Consideration of draft amendments to existing

UN Regulations submitted by GRSP

Proposal for Supplement 8 to the 01 series of amendments to Regulation No. 129 (Enhanced Child Restraint Systems)

Submitted by the Working Party on Passive Safety *

Figure 3

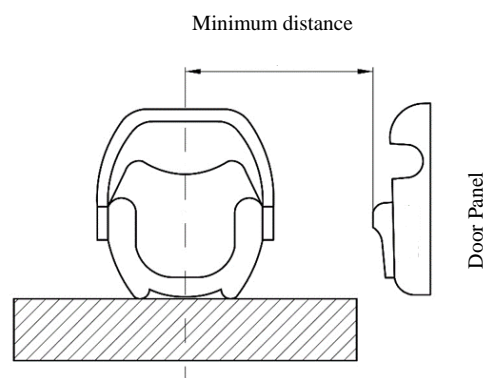
For each test, the initial position of the side impact door panel relative to the bench shall be adjusted according to the minimum distance between the vehicle's door panel and the centre of the seating position as shown in Figure 3.
